## PLANNING DIVISION STAFF REPORT

July 7, 2025

**Project Address:** 709 Northport Drive (18<sup>th</sup> Alder District)  
**Application Type:** Conditional Use and Certified Survey Map Referral  
**Legistar File ID #** [88336](#) and [88558](#)  
**Prepared By:** Chris Wells, Planning Division  
Report includes comments from other City agencies, as noted.  
**Reviewed By:** Kevin Firchow, AICP, Principal Planner

***Image A: The Site Plan Overlaid on the Aerial Showing the Proximity of the Residential to the West and Proposed Massing Stepbacks at the Fourth Floor Level***

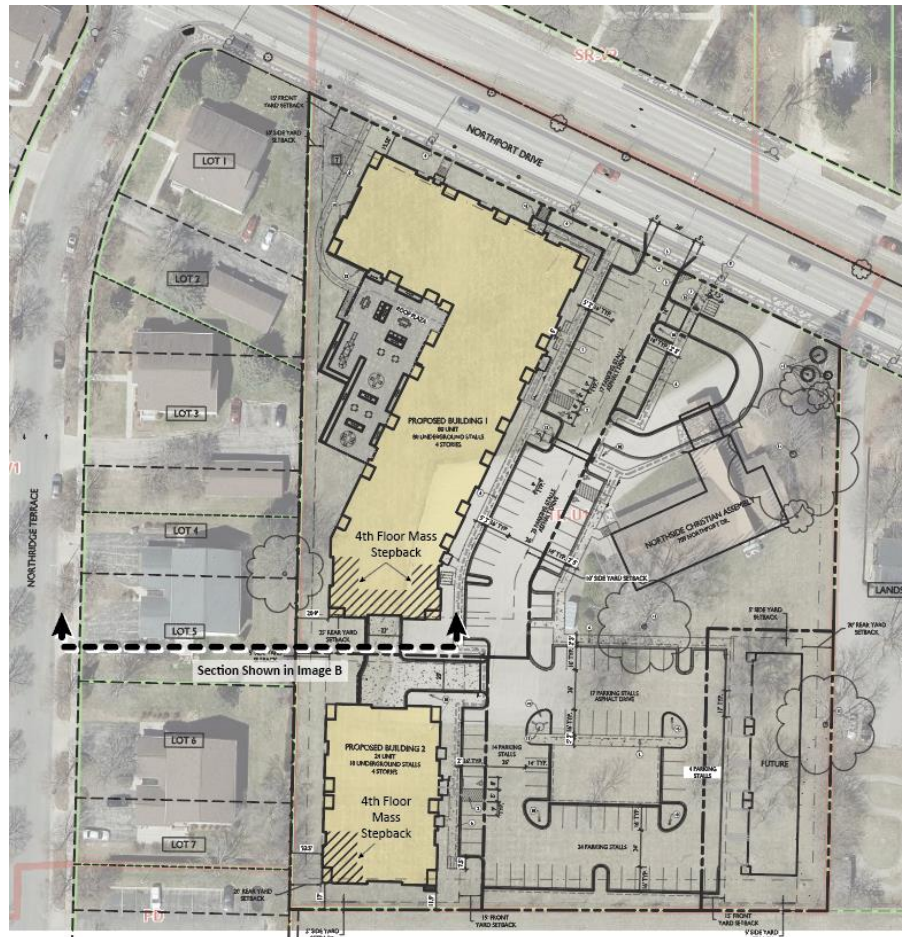
Second, the applicant has introduced setbacks in certain locations at the fourth-floor level along portions of the west façades – by locating the fourth floor rooftop patios at the south end of the 80-unit building and southwest corner of the 24-unit building. (These rooftop patios are indicated with a diagonal hatched line in Image A (see right).

In response to Planning’s staff’s follow-up questions regarding setbacks, the applicant indicated they would be willing to move the setback at the southern end of the building to the western wing, but raised programmatic concerns of creating setbacks at both locations. Staff note that the residential building located near the current setback is closer than the one at the north, and therefore, believe that it may be more impactful as proposed.

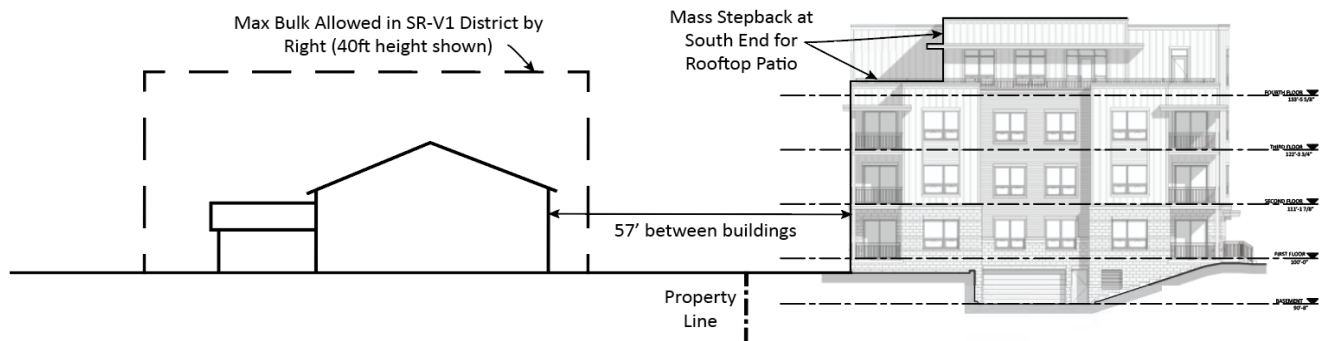
Image B (below) shows the relationship between the proposed buildings and the adjacent residential lots to the west – which contain gable-roofed, two-story, four-unit buildings and are zoned SR-V1 (Suburban Residential – Varied 1). While these lots are currently developed at a lower intensity than what is allowed by the Zoning Code, Staff note that SR-V1 allows such buildings as 3- to 4-unit, single-family attached dwellings and 3- to 8-unit multi-family buildings, up to three stories and 40-feet in height, as permitted uses.

Image B depicts a dashed line estimating the maximum building bulk currently allowed by right in the SR-V1 District. While the transition from the proposed flat-roofed, four-story buildings to these tall, two-story buildings is roughly two stories, the proposed building is approximately only one-story taller than what is currently allowed, by right, on these abutting sites.

Regarding building height, before final sign off by Zoning, the applicant will need to make sure the height of the 24-unit building is not greater than 52 feet (Zoning is currently measuring it at 53 feet).
